**RE: OUR LADY OF THE ROSARY CHURCH (K11-D57). GRADING AND DRAINAGE
PLAN FOR BUILDING PERMIT APPROVAL. ENGINEER'S STAMP DATED
AUGUST 27, 1997.**

GRADING AND DRAINAGE PLAN

OUR LADY OF THE ROSARY CHURCH

GRADING PLAN

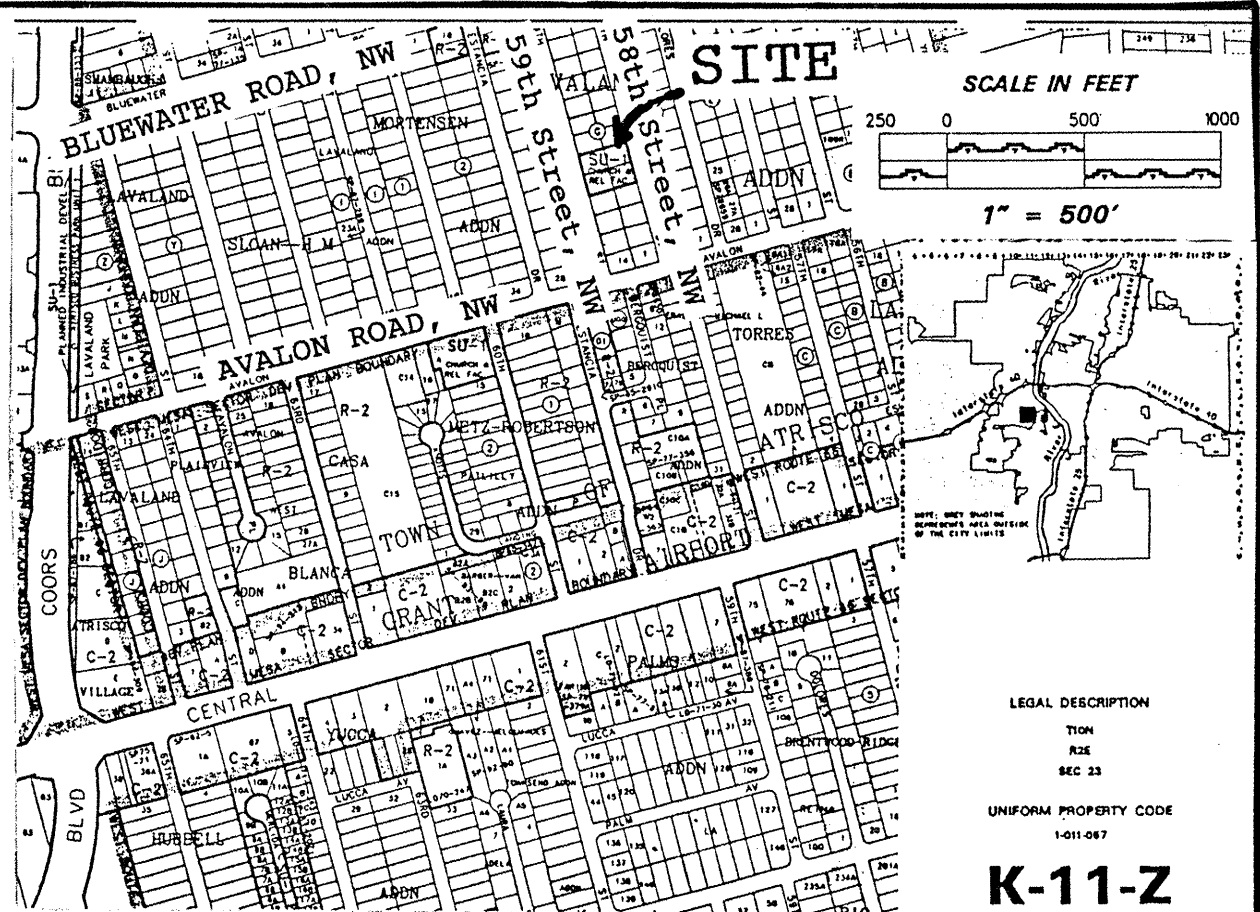
Prior to Building Permit approval, you will need to either re-plat the four lots into one lot, or provide cross lot blanket drainage easements. The plat you submitted is not a very legible copy and I am unable to read it. If you choose to provide a blanket easement, you must show the lot lines on your grading and drainage plan.
